**Title:** Permit #24-525: 26275 Smithtown Road Driveway and Utility Installation

**Prepared by:** Name: Veronica Sannes, Permitting Technician  
Phone: (952) 641-4580  
vsannes@minnehahacreek.org

Approval of MCWD permit 24-525 in accordance with the submitted plans and with the following conditions:

**26275 SMITHTOWN RD LOT SPLIT**  
 SHOREWOOD, MINNESOTA  
**PEBBLE CREEK CUT-FILL MAP**  
 FOR  
**TONY AND AMY DENMAN**  
 26275 SMITHTOWN RD

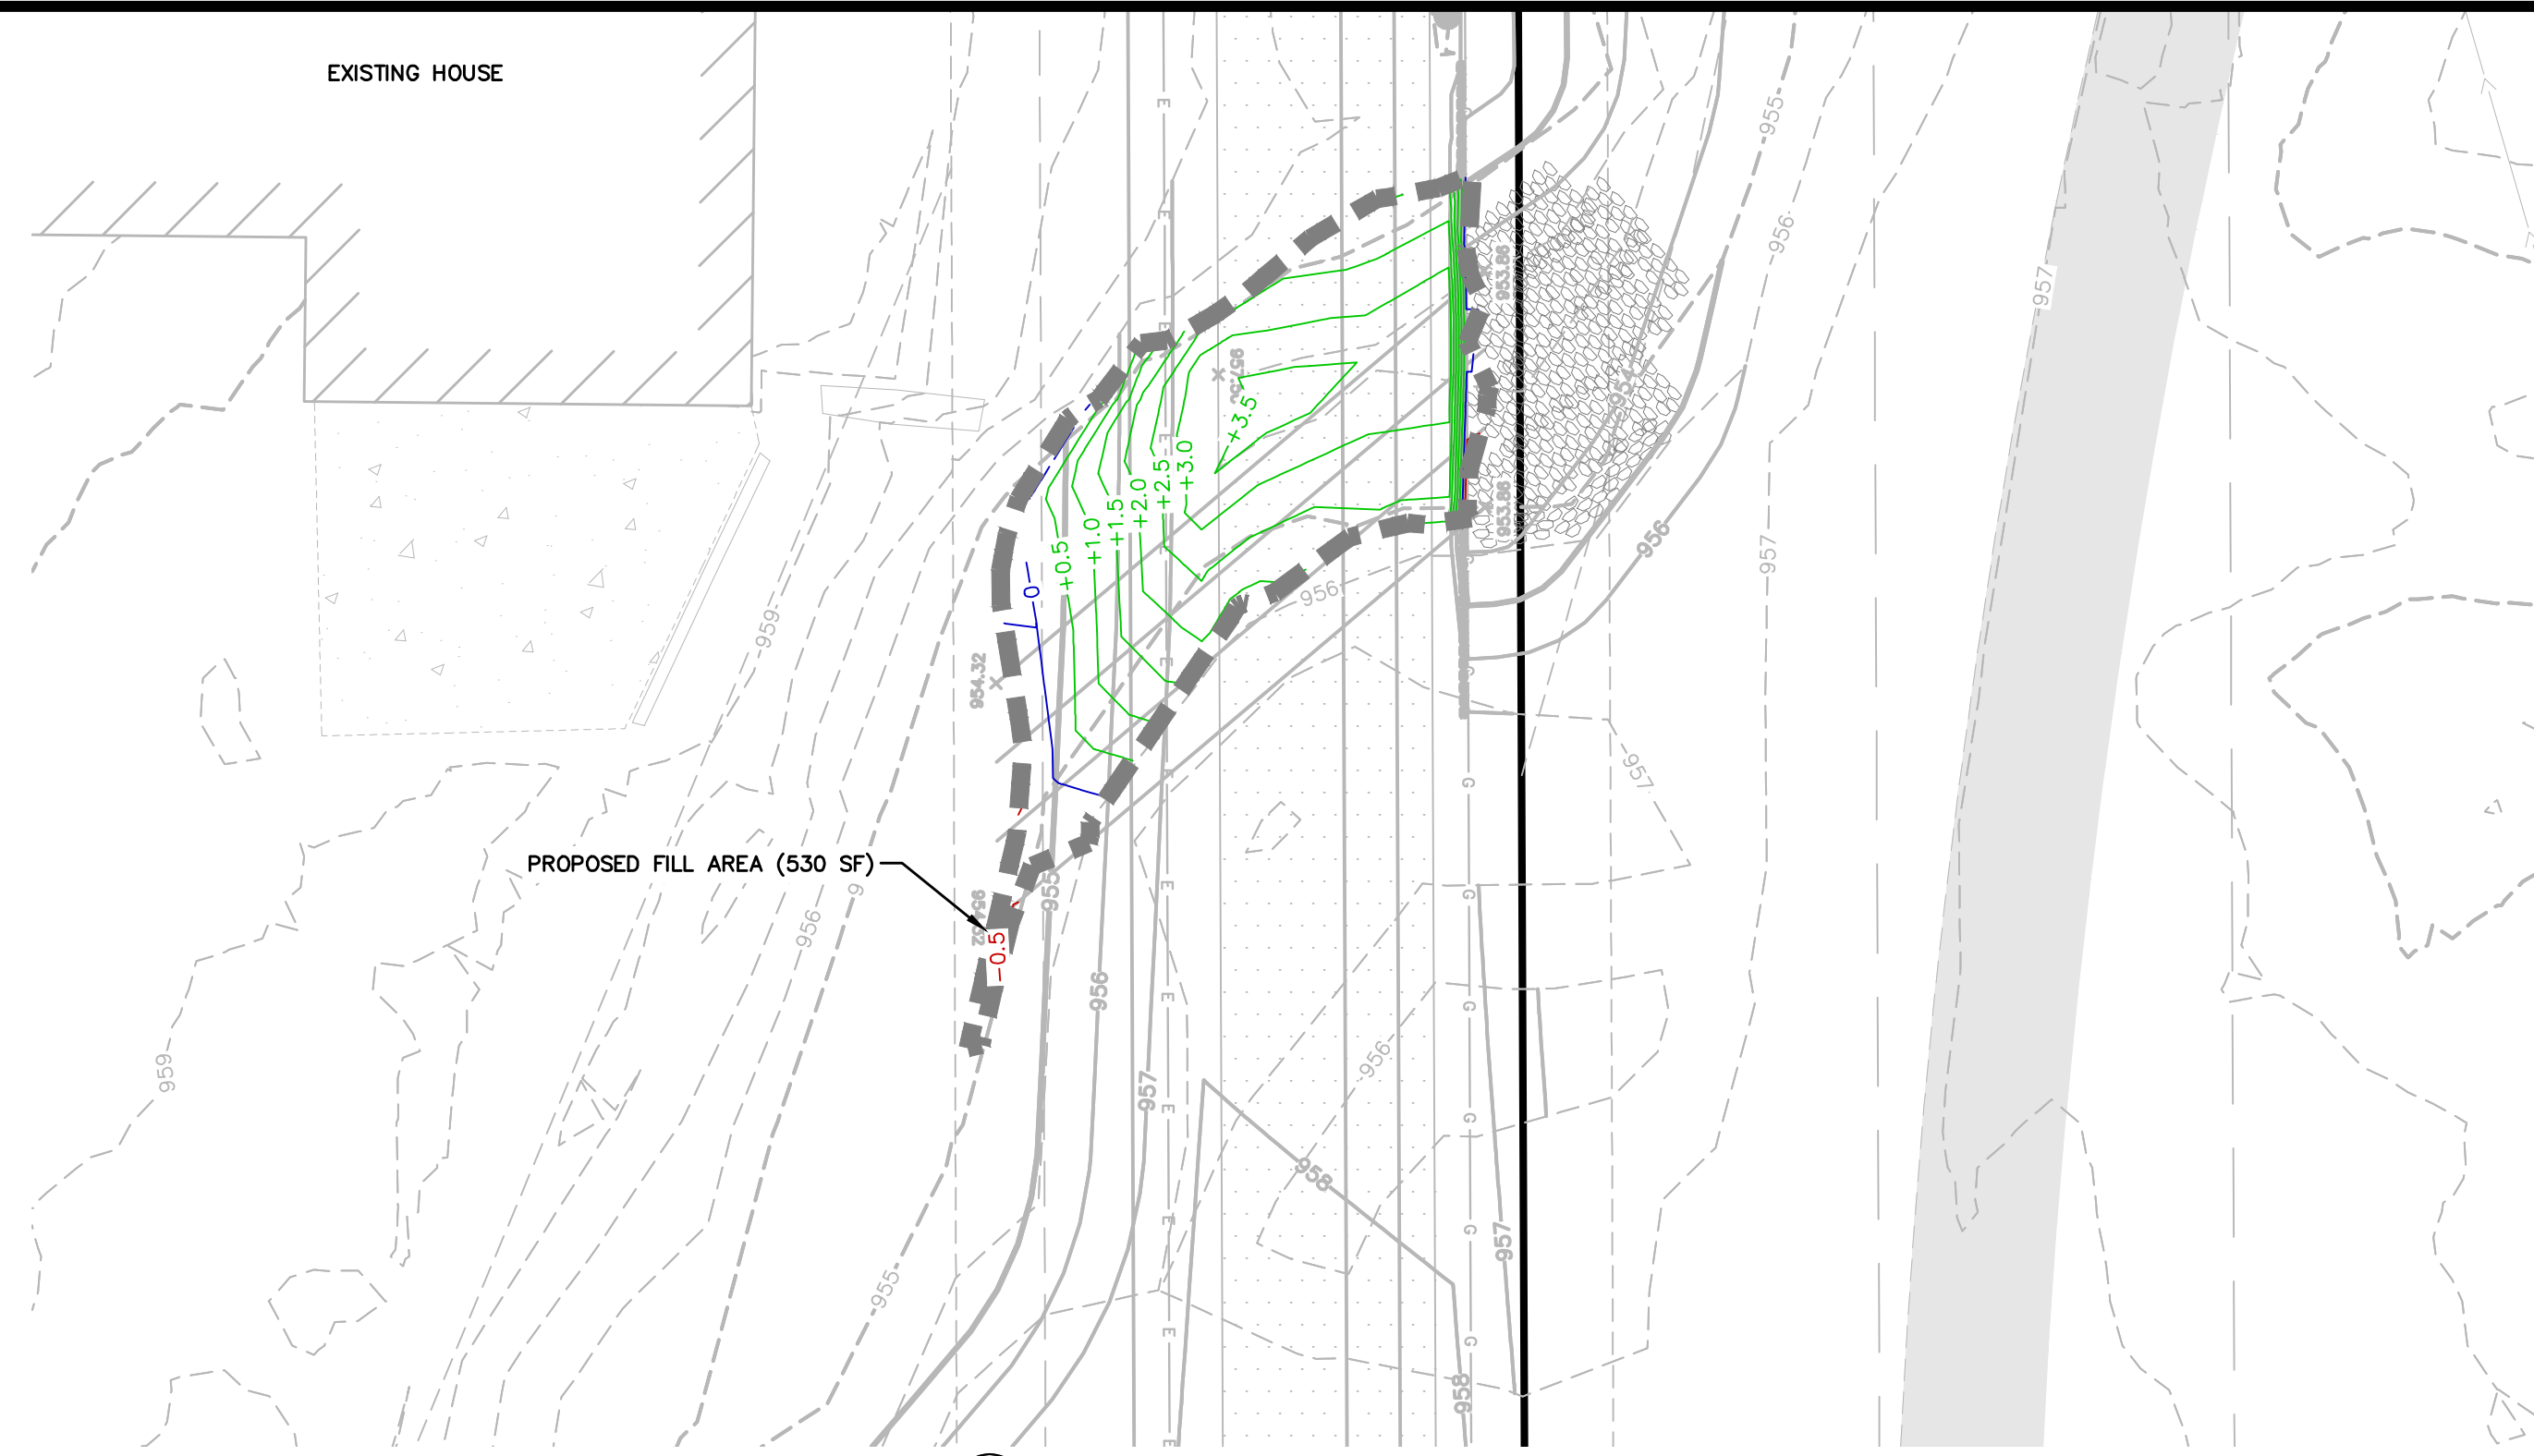
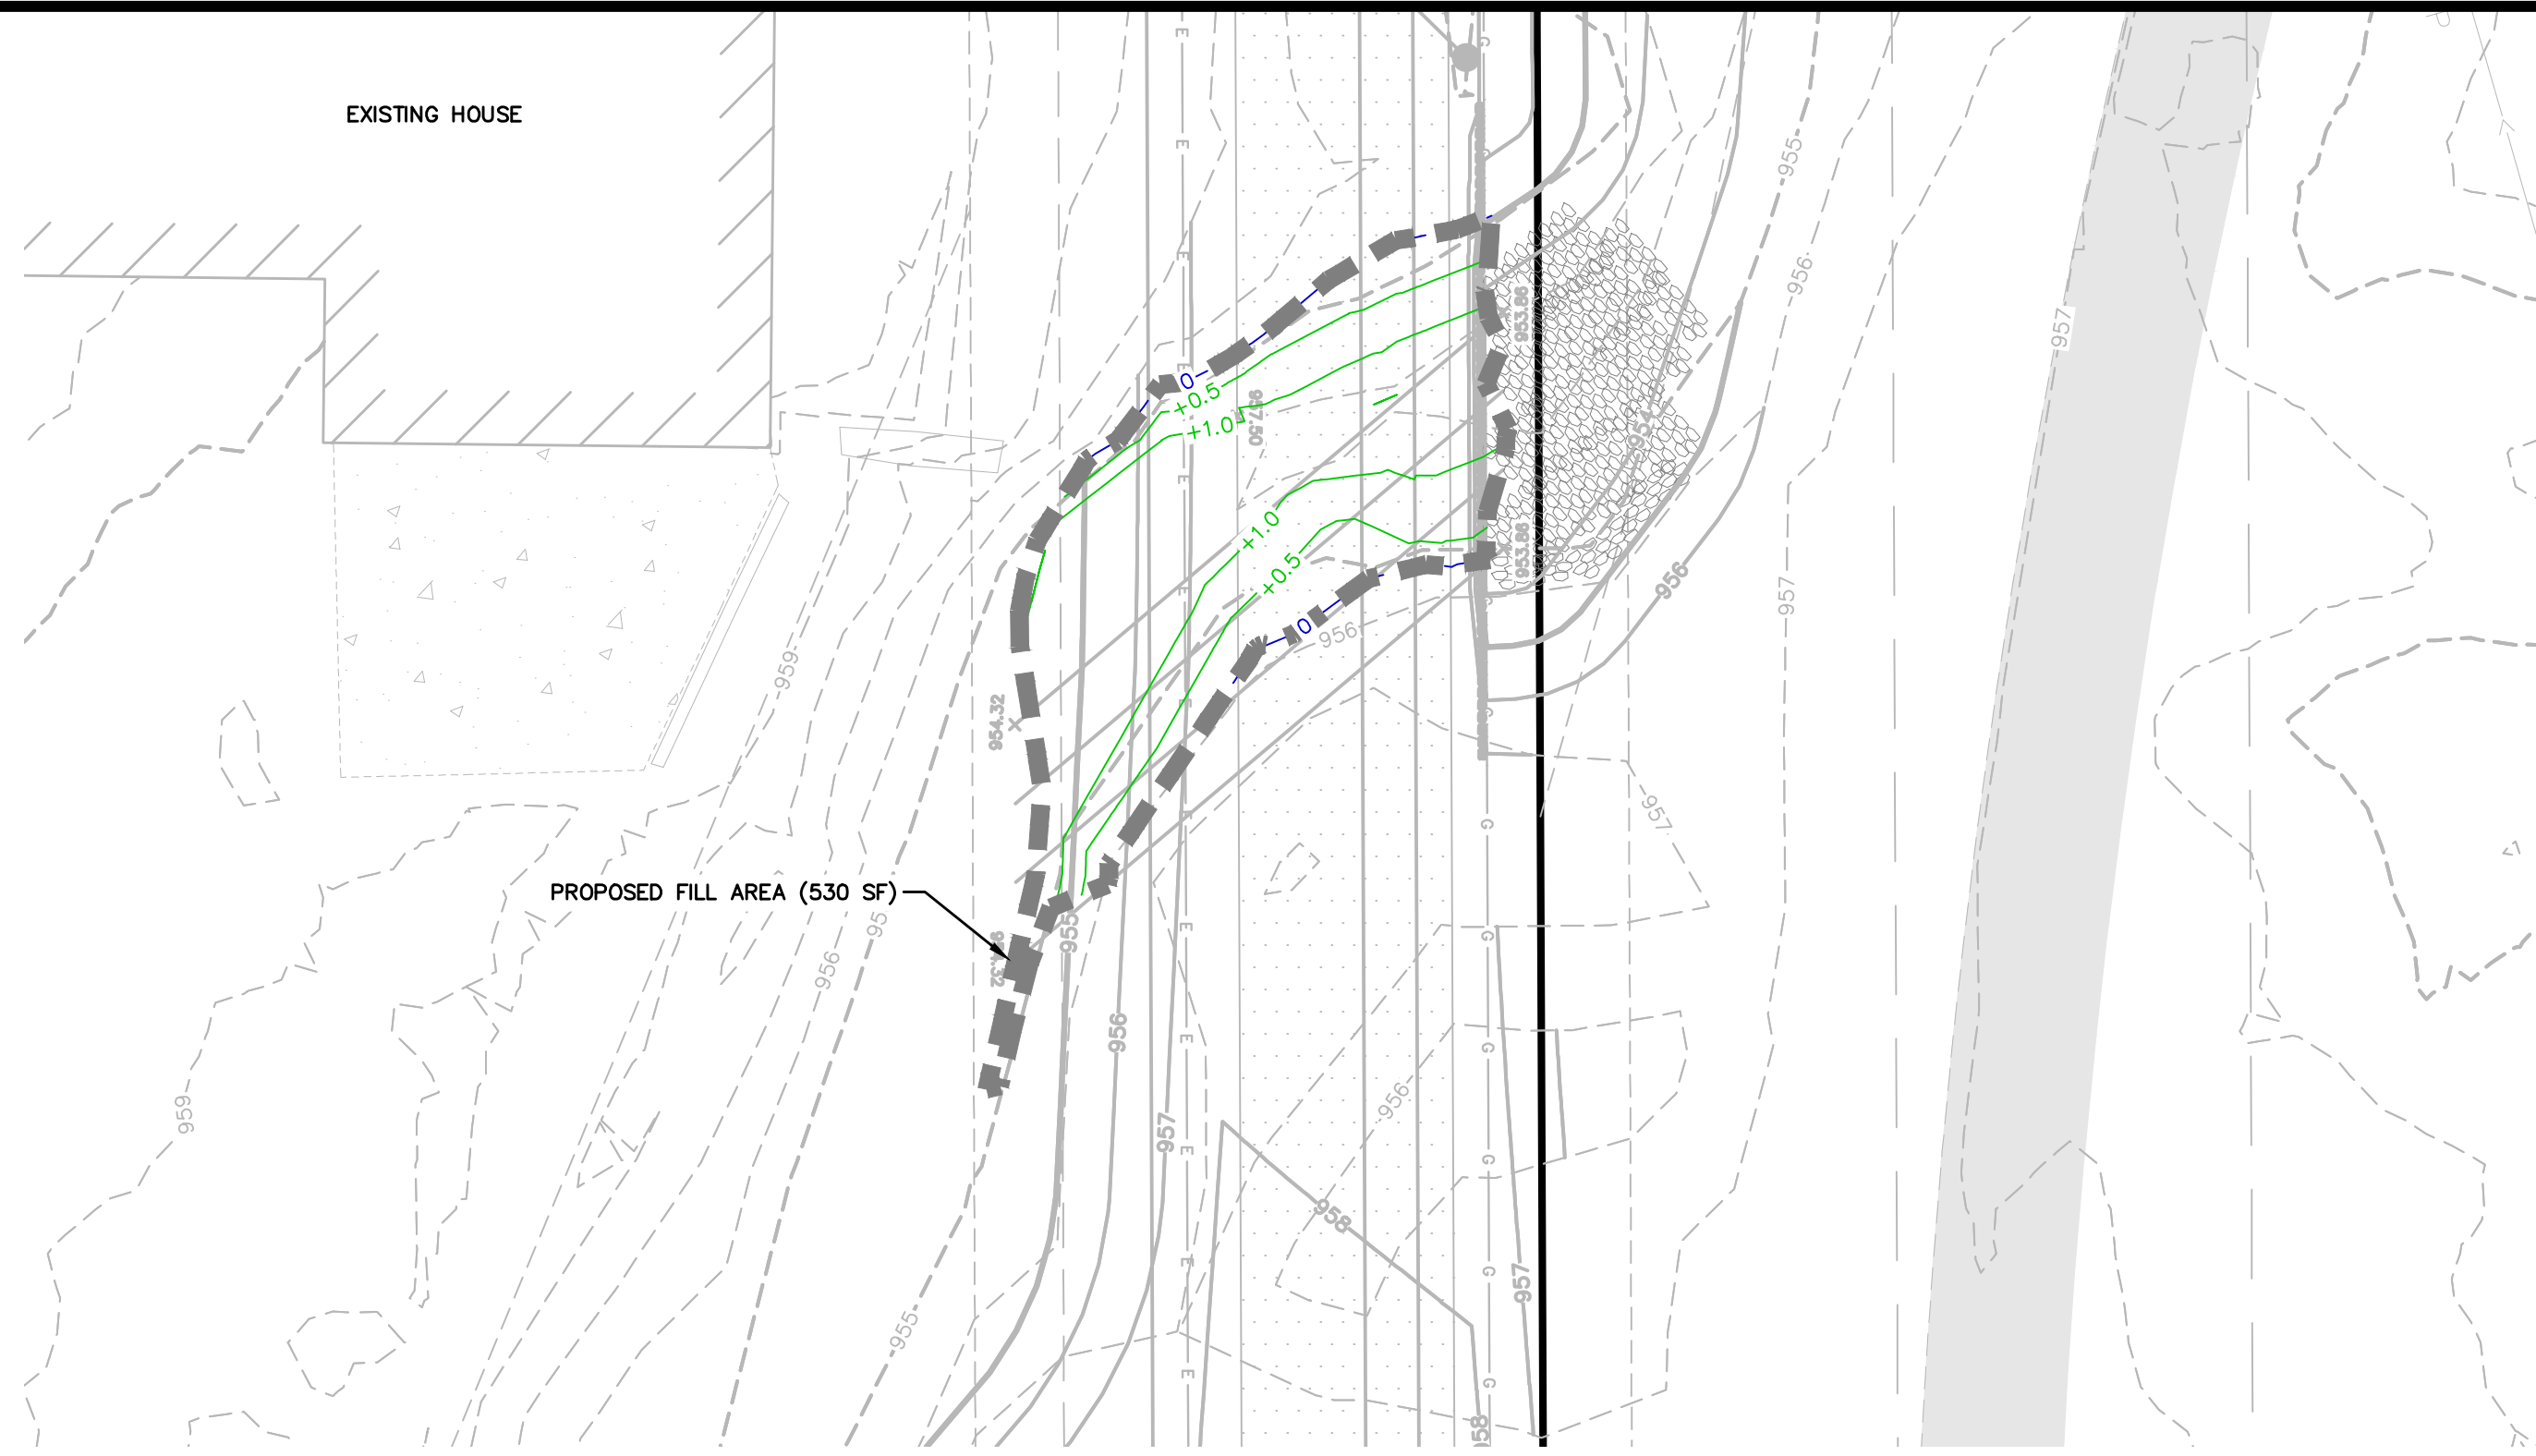
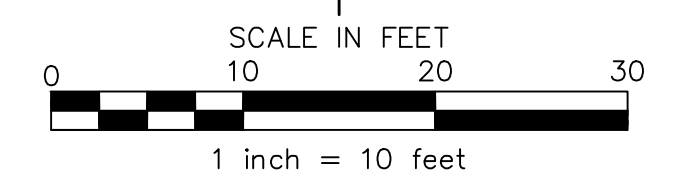
Section 4(a) states that any floodplain fill must be offset so there is no loss in flood storage between the ordinary high water (OHW) and 100-year floodplain elevation. The Project proposes 13.36 cubic yards of fill within the 100-year floodplain of the stream. This fill is due to the culvert installation. To offset the fill, the applicant proposes 15.51 cubic yards of compensatory storage, resulting in the creation of 2.15 cubic yards of net floodplain storage.
